SERVICE 		1
		X 93.135-26

Models 254,257,262

Bar bolt

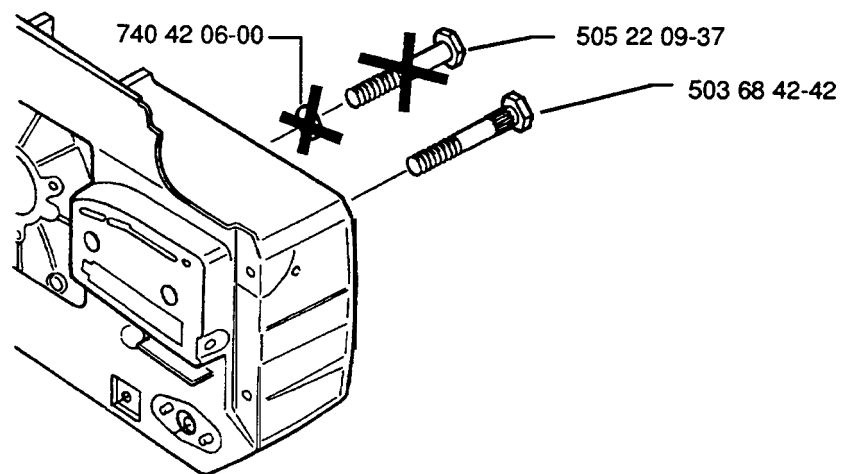
A modified bar bolt is introduced on the above mentioned models at the same time as the crankcase is changed. The O-ring and the knurling on the bar bolt are excluded.

The previous bar bolt, ref. no. 505 22 09-37, can be used in the earlier as well as the later design of crankcase.

Bar bolt, ref. no. 503 68 42-42, can only be used in crankcases of later design.
